# **MONITORING YEAR 1 ANNUAL REPORT**

## **CANDY CREEK MITIGATION SITE**

RE: Draft Monitoring Year 1 Report Comments  
Candy Creek Mitigation Site (DMS #96315)  
DMS Contract Number 5794  
RFP Number 16-005568  
Guilford County, NC

We have reviewed the comments on the Monitoring Year 1 Report for the above referenced project dated January 9, 2018 and have revised the report based on these comments. The revised digital files are submitted with this letter. Below are responses to each of your comments. For your convenience, the comments are reprinted with our response in italics.

Figure 3.6 Integrated Current Condition Plan View  
Candy Creek Mitigation Site  
DMS Project No. 96315  
Monitoring Year 1 - 2017  
Guilford County, NC

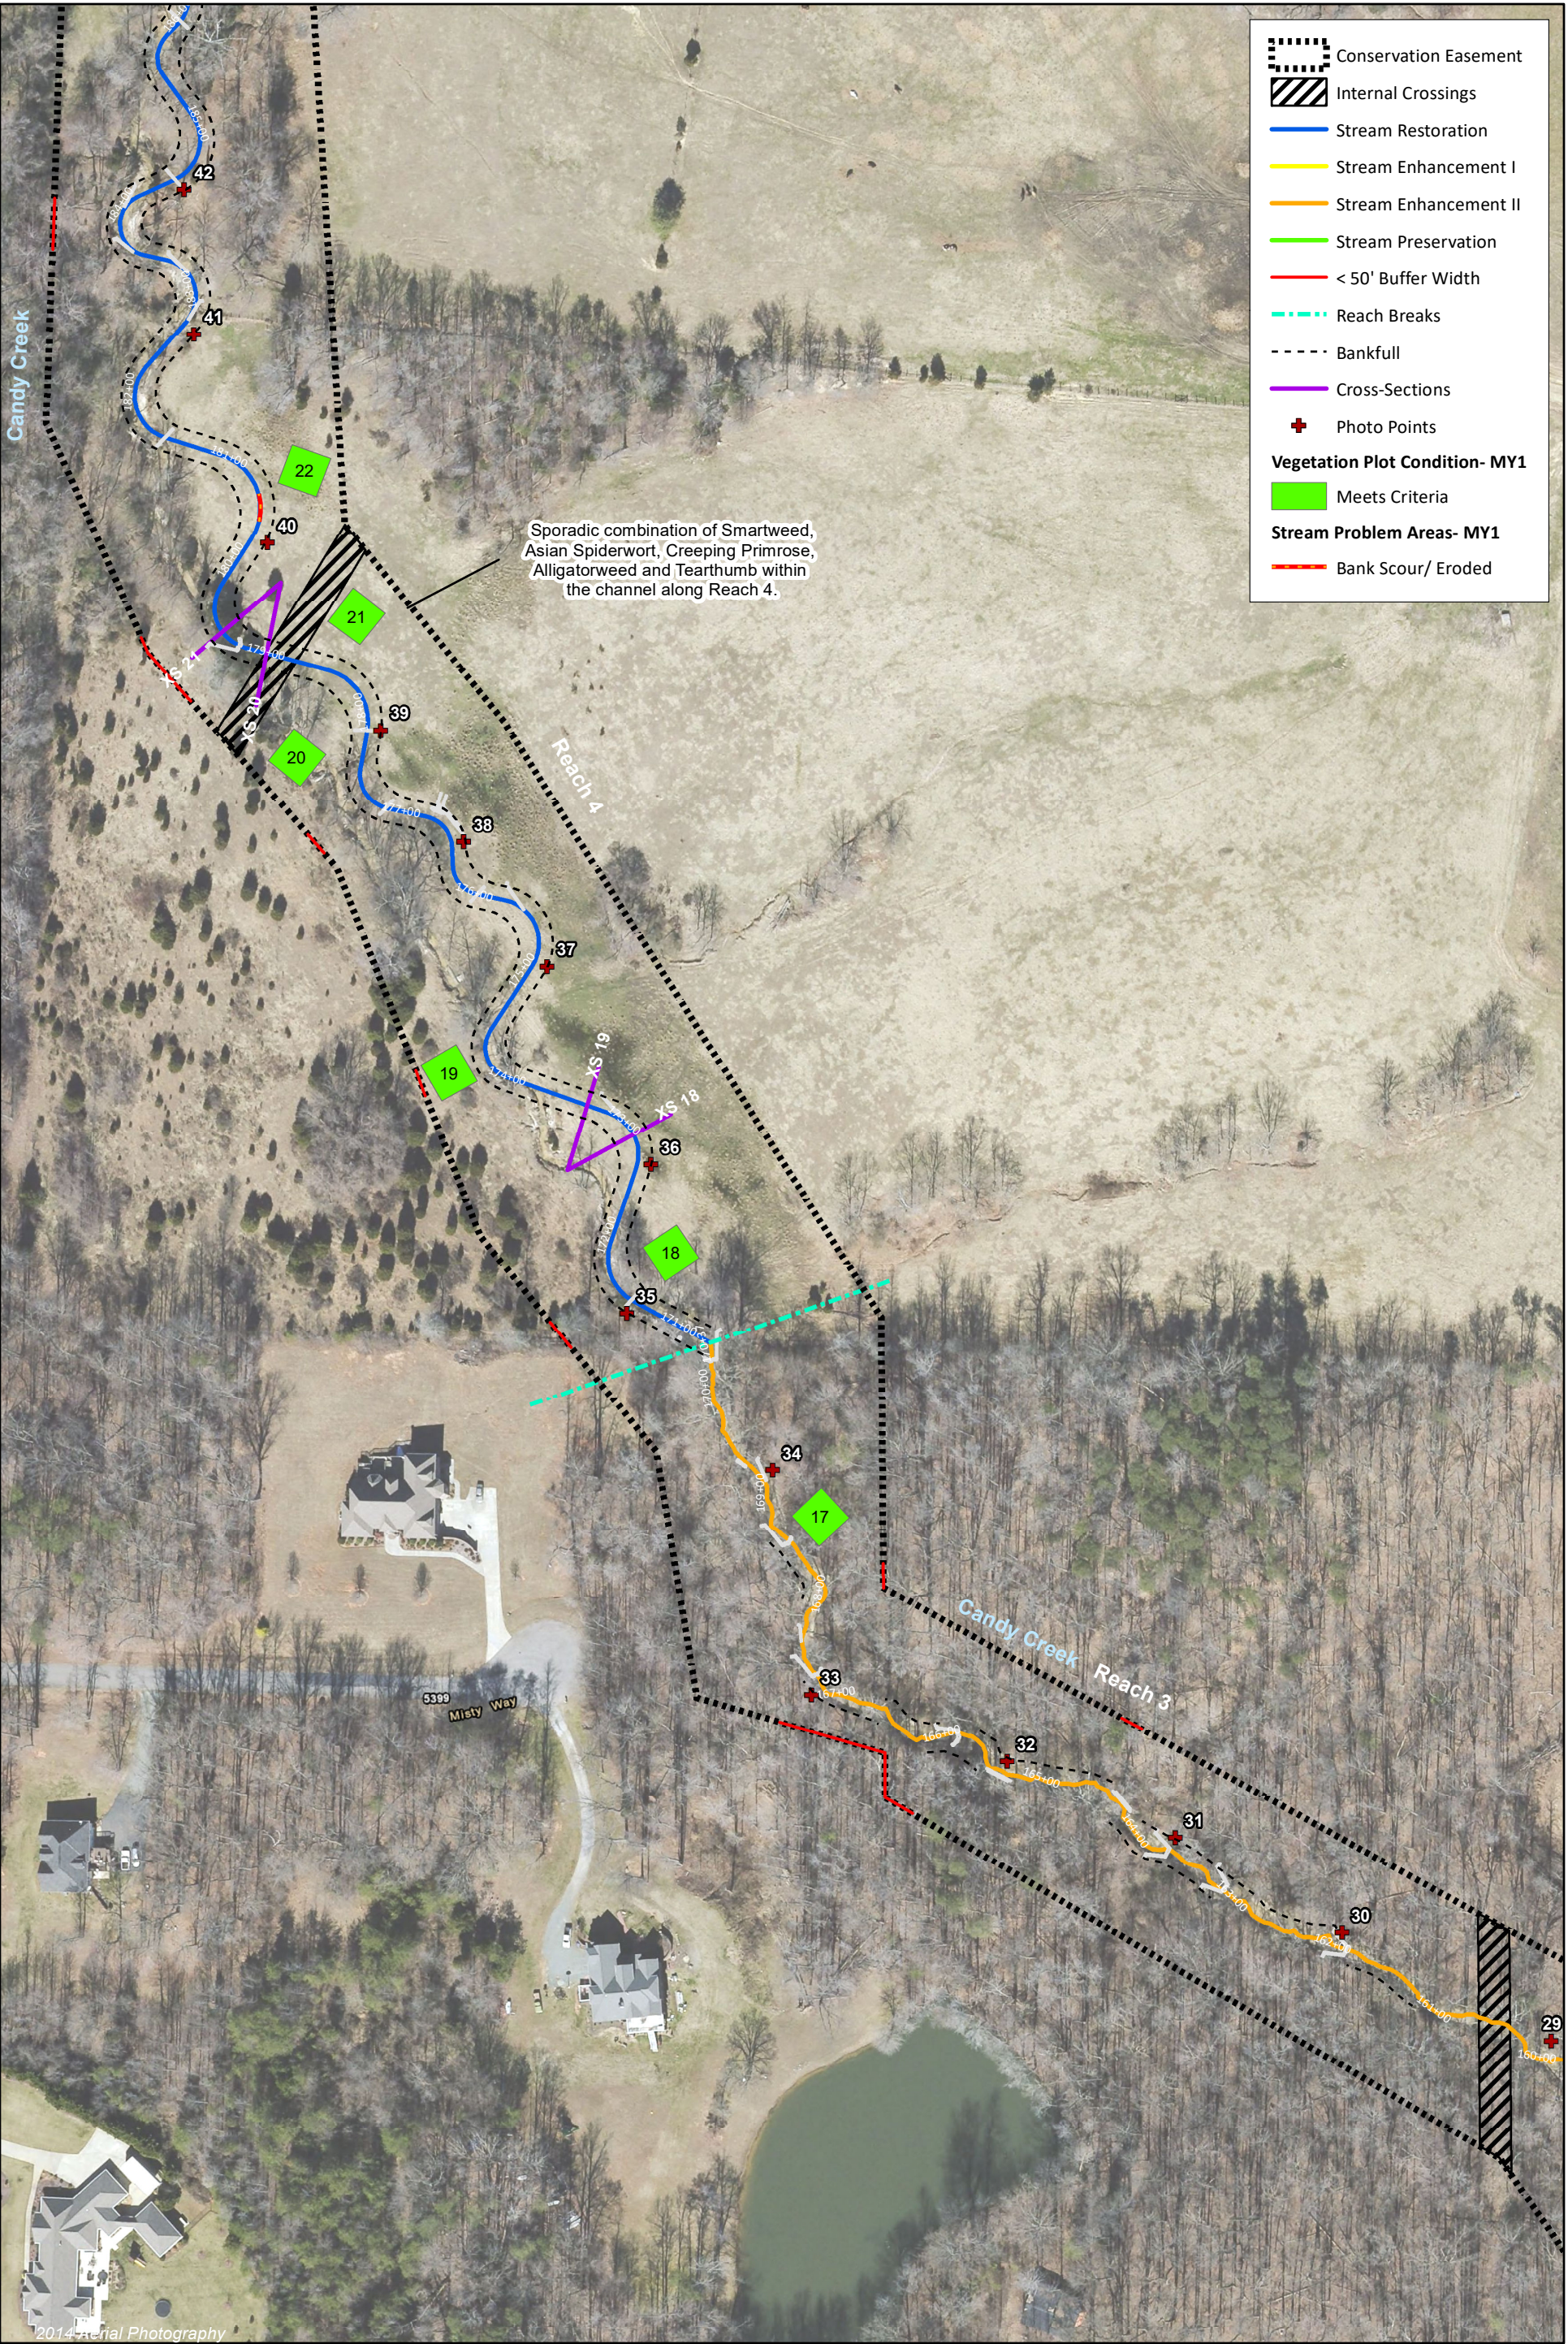
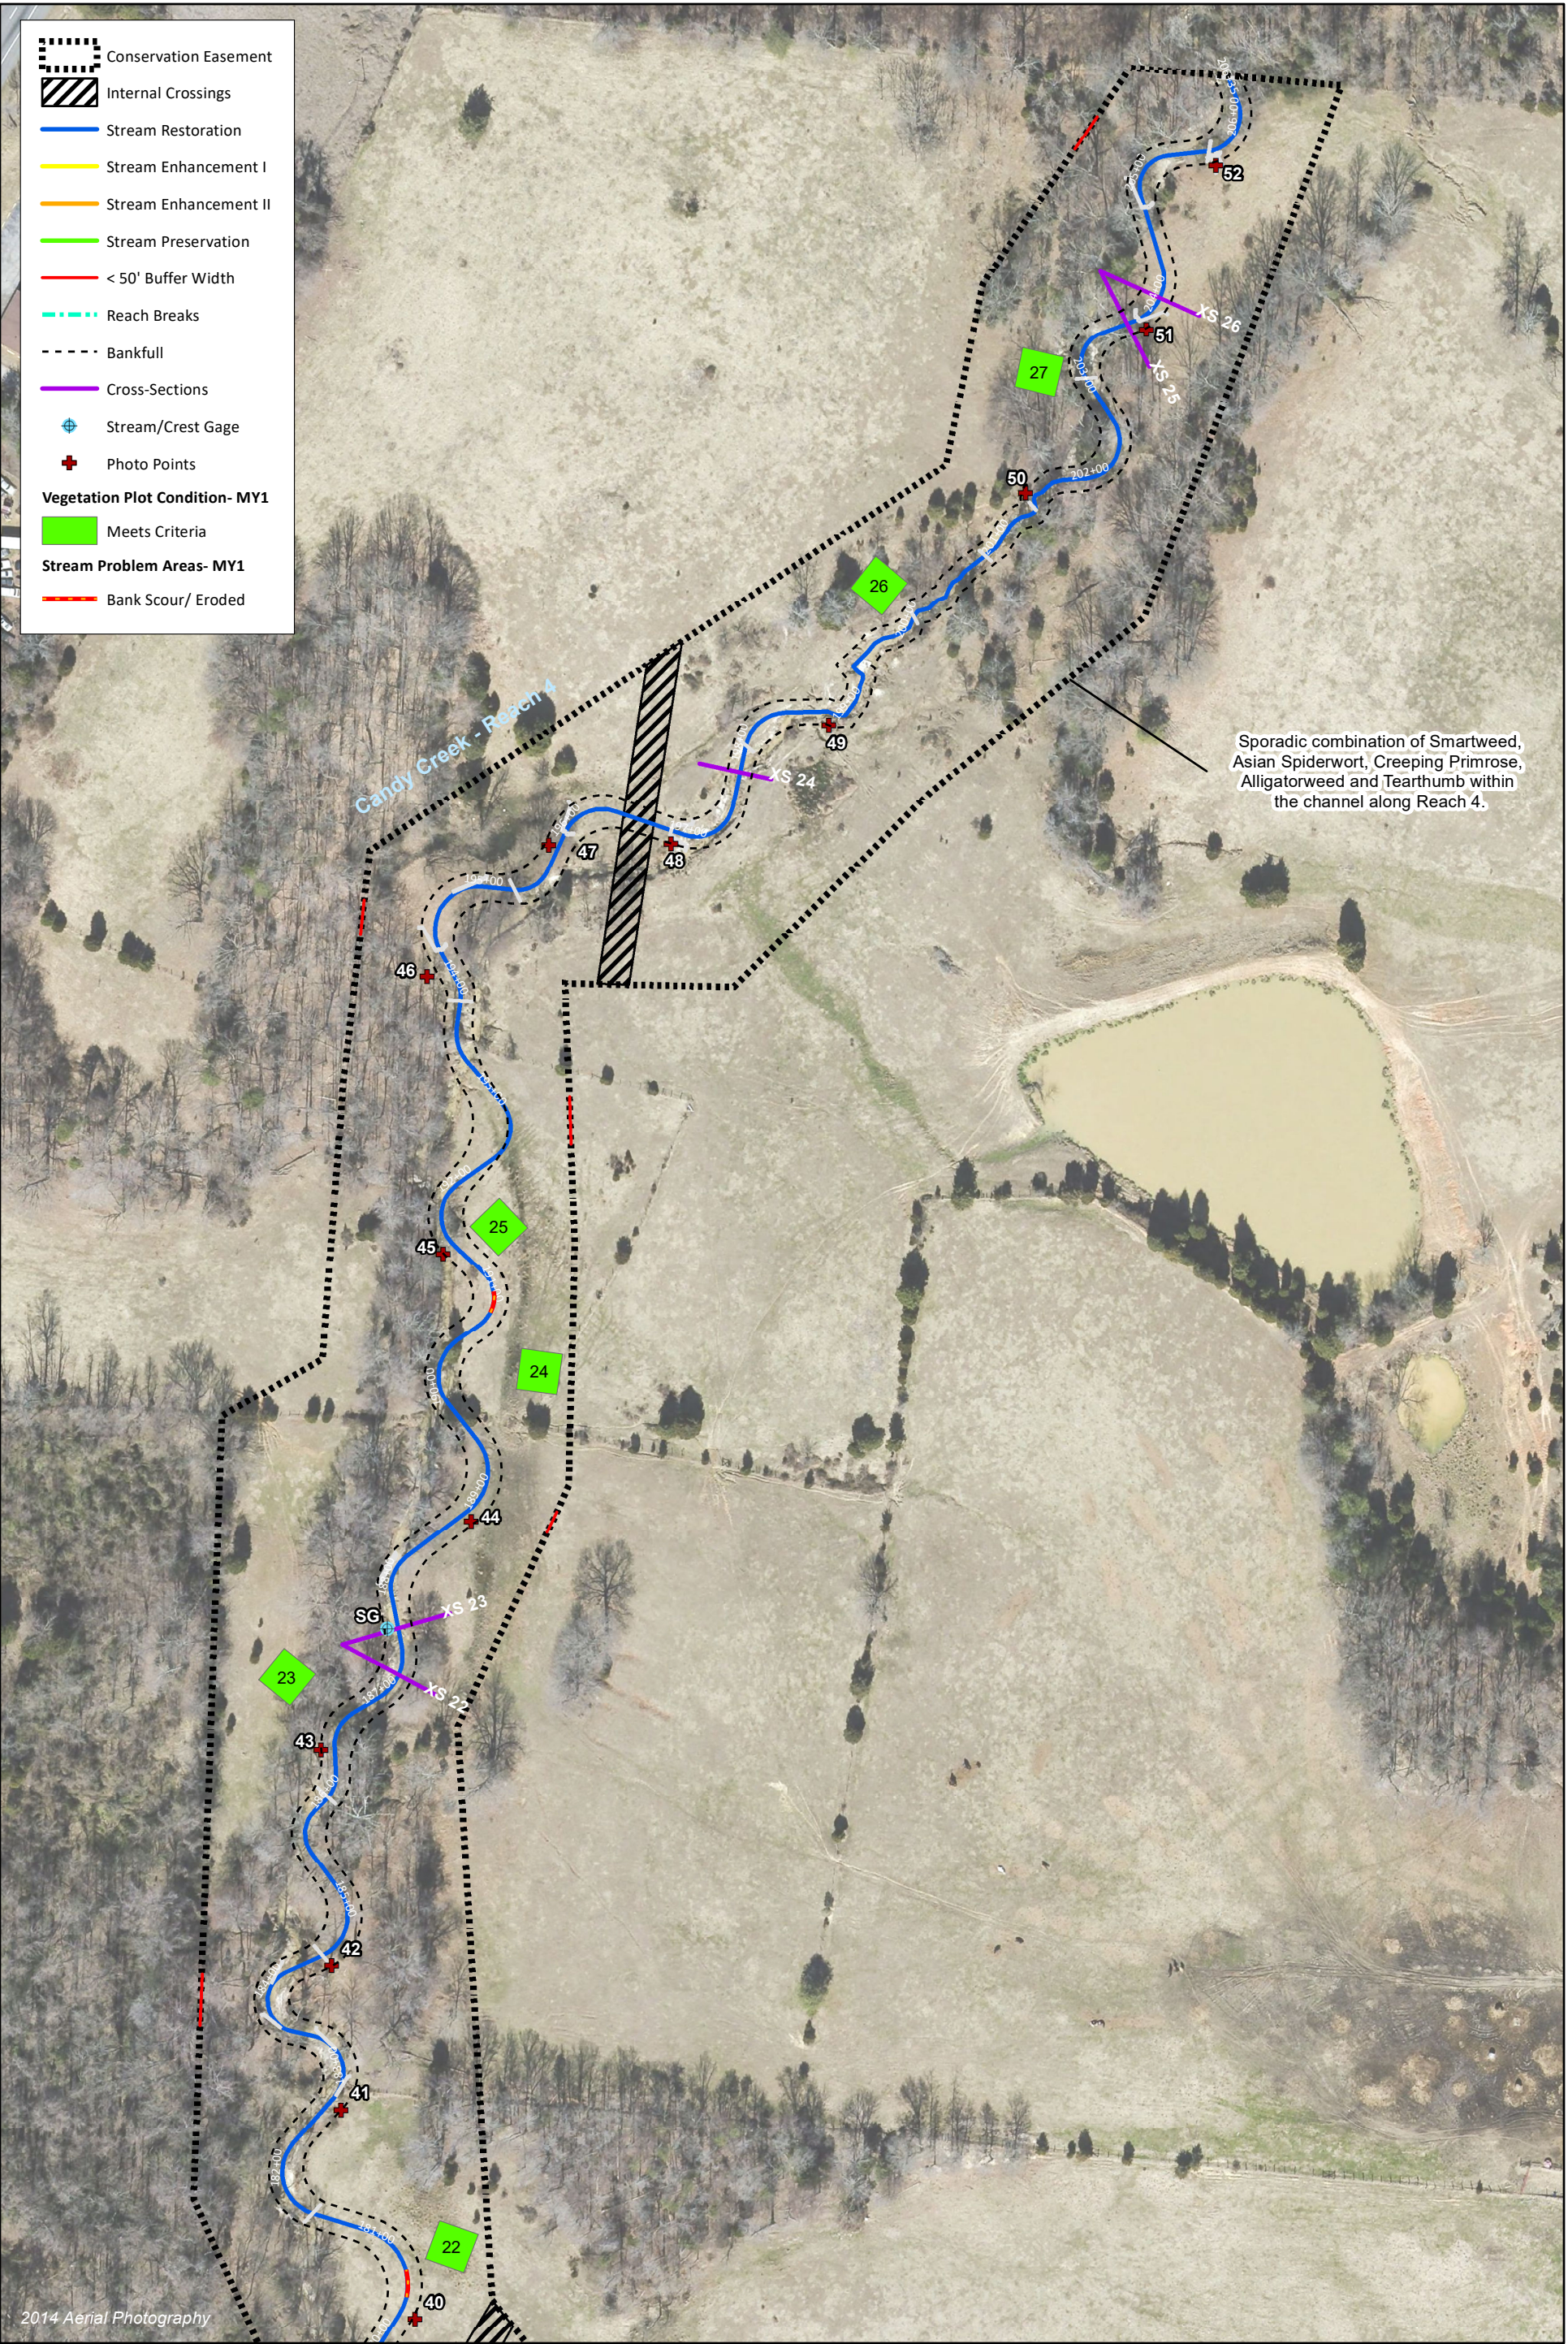
3. The CCPV shows sections along Candy Creek Reach 1, UT4, UT5, Candy Creek Reach 2, UT2 Reach 1, Candy Creek Reach 3, UT1C and Candy Creek Reach 4 where the buffer width is less than 50 feet. Wildlands addressed this in the As-Built Baseline report and indicated that the total length of these sections is approximately 3.1% of the total project length. Please address this in a sentence or two in the MY1 report and include that this is less than the 5% allowed by the IRT.

*An explanation was added to the end of the executive summary, page ii and section 1.2, page 1-2.*
